## LARAMIE COUNTY PLANNING & DEVELOPMENT DEPARTMENT

### MEMORANDUM

**TITLE:** Review and Action on a Class B Conditional Use Permit for the Microsoft CYS07 Parking Area and Laydown Yard, located in a parcel of land situated in the SW ¼ NE ¼ of Section 5, Township 13 North, Range 67 West, of the 6<sup>th</sup> P.M., Laramie County, WY.

**RE: RESPONSE TO PERMIT NUMBER: PZ-25-00070**

**IV. ENGINEER'S CERTIFICATION**

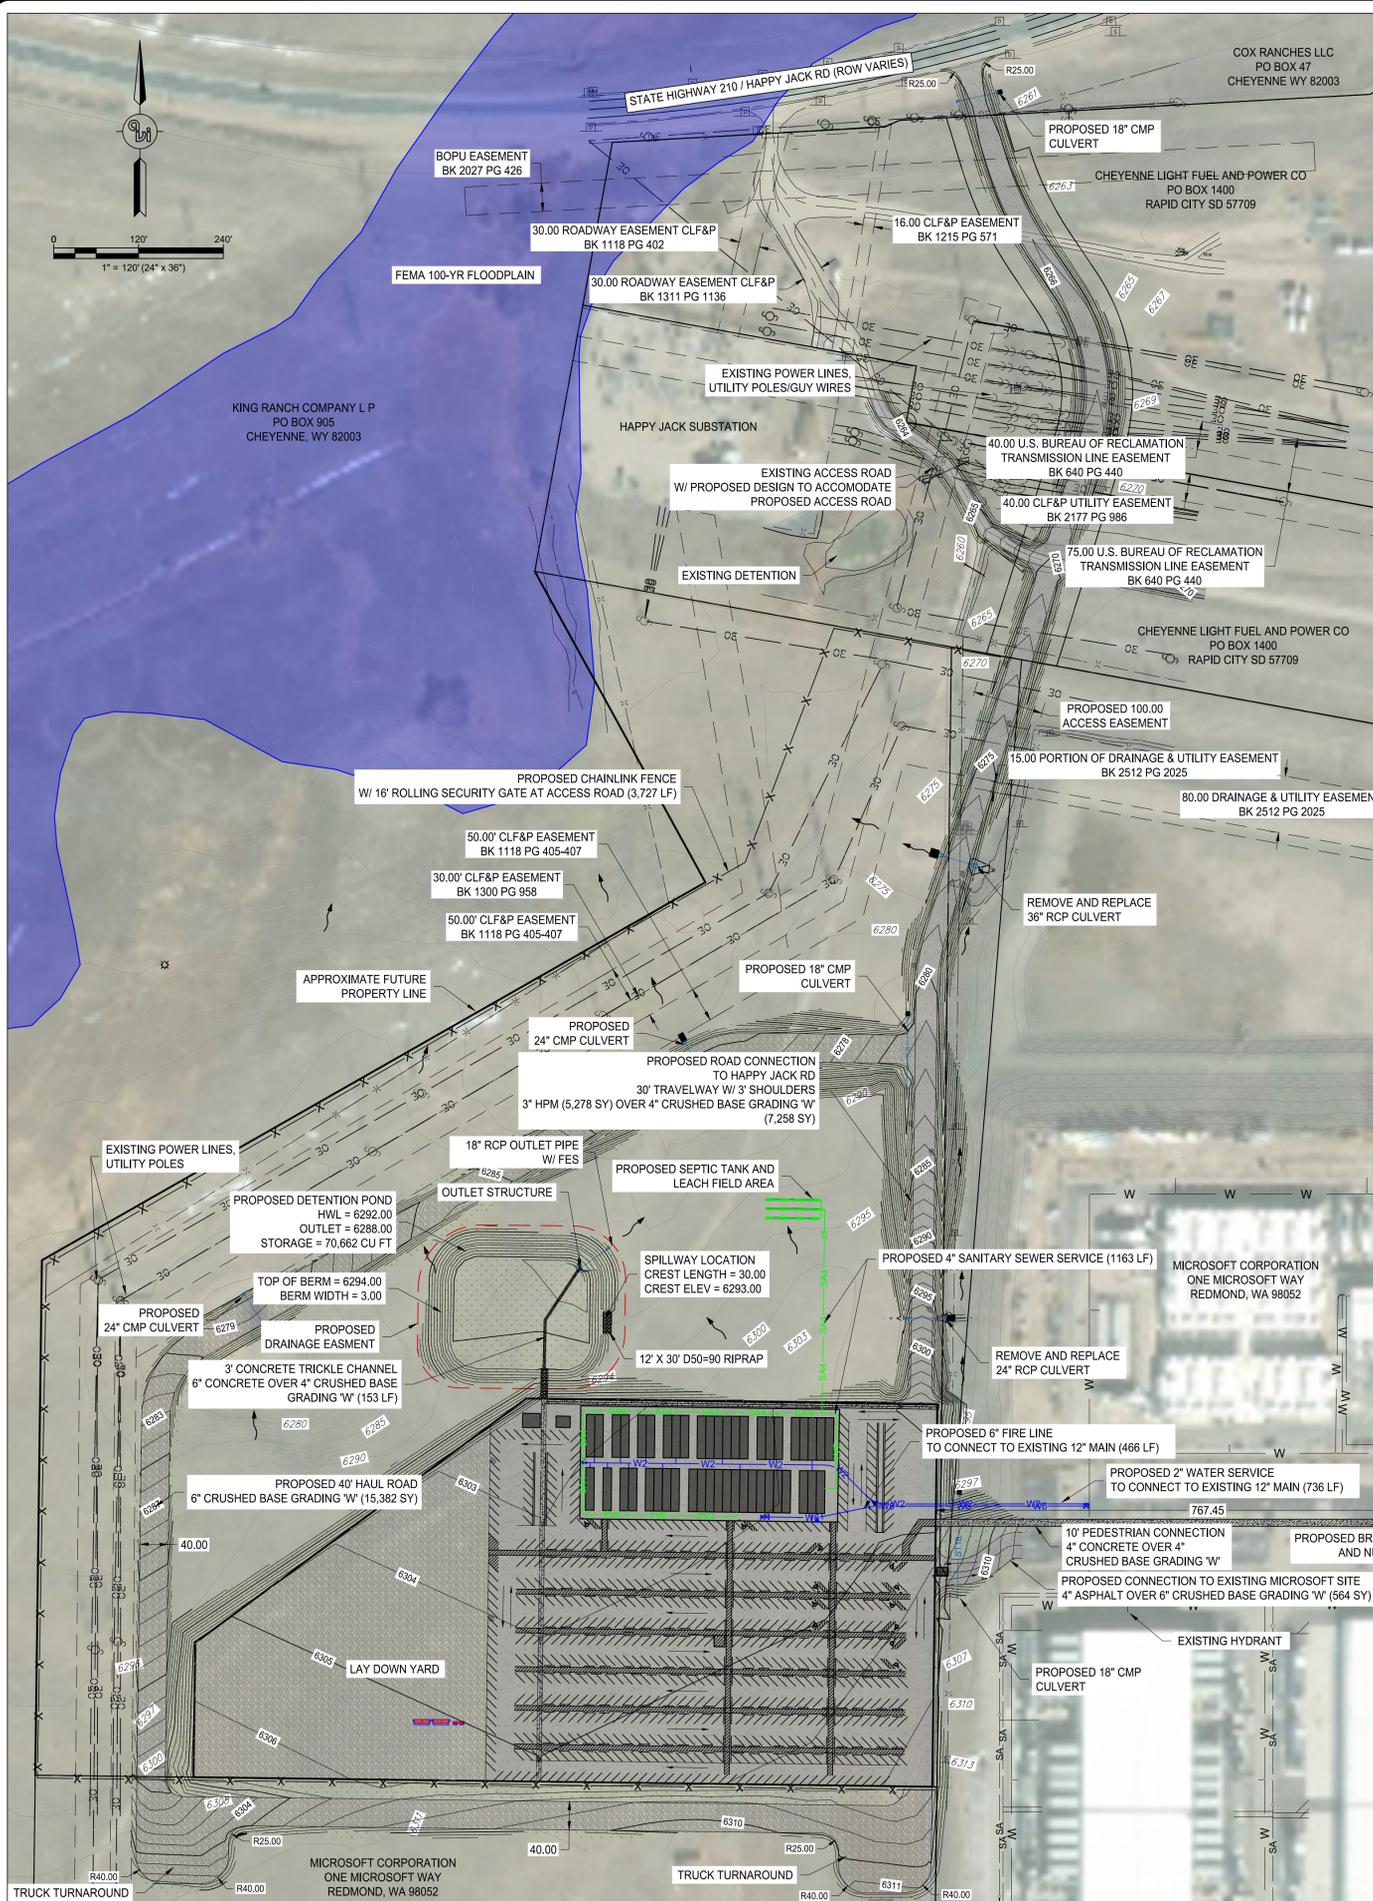
- 7) I believe the engineers certification in the Drainage Report (pg. 2) refers to the incorrect project. **Corrected**
- 8) What is the velocity coming out of the outlet pipe from the detention pond? Does it require riprap to prevent erosion? **Please see revised drainage report.**

**SITE PLAN FOR CYS07 STAGING AREA**  
 A PARCEL OF LAND BEING SITUATED IN THE SW¼ OF SECTION 5, T13N, R67W OF THE 6TH PRINCIPAL MERIDIAN, CHEYENNE, WYOMING  
 PREPARED DECEMBER 2025

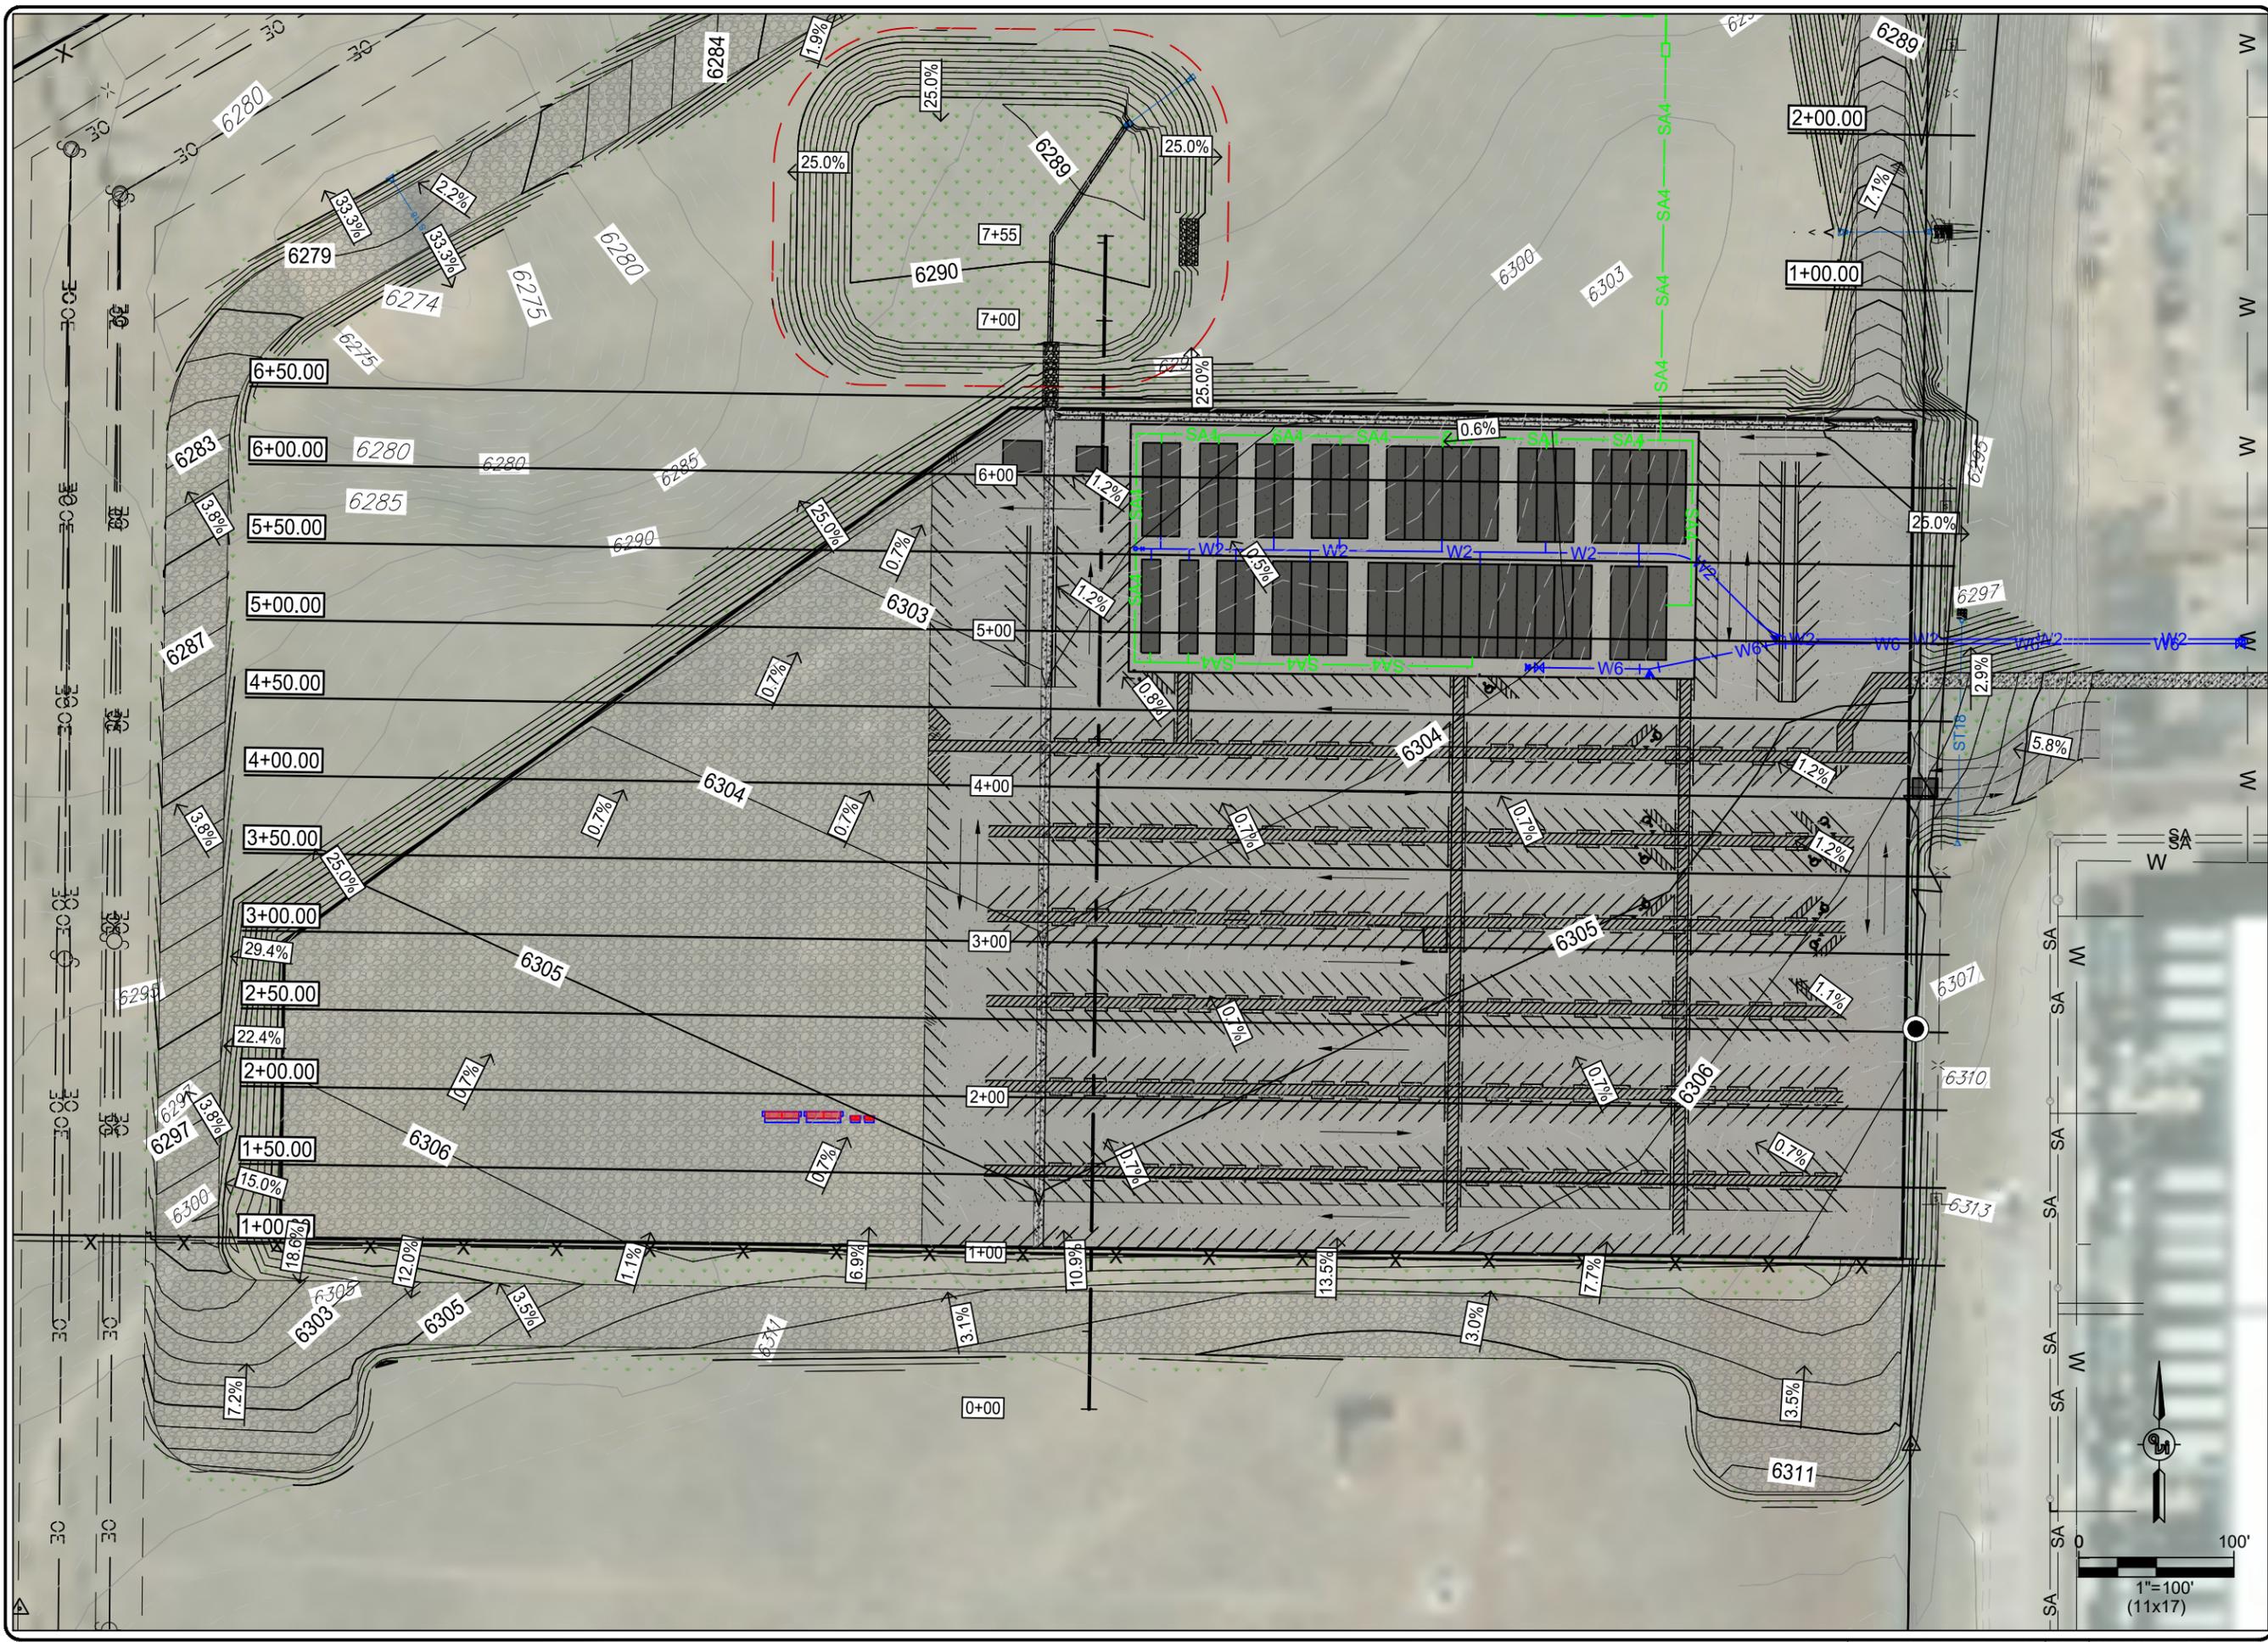
- 1) Please include the radii dimensions for the access road off Happy Jack Road on the site plan and construction plans. **Added, also please note that efforts are underway directly with WYDOT to complete the design for this approach.**

- 2) Per 3-1-109g.xxvi and 5-2-102.j, the site plan needs to include a recorded drainage easement encompassing the detention pond. **Noted, drainage easement identified on the plans, and intended to be recorded upon approval of design.**

- 3) Will there be any trash dumpsters/receptacles associated with the job trailers, etc.? **See revised site plan and SWPPP map for proposed trash dumpsters and locations.**

12) It would be helpful and prudent if the FEMA floodplain is shown on the site plan to show all work will be outside of the floodplain area. **Floodplain now shown on the site plan.**
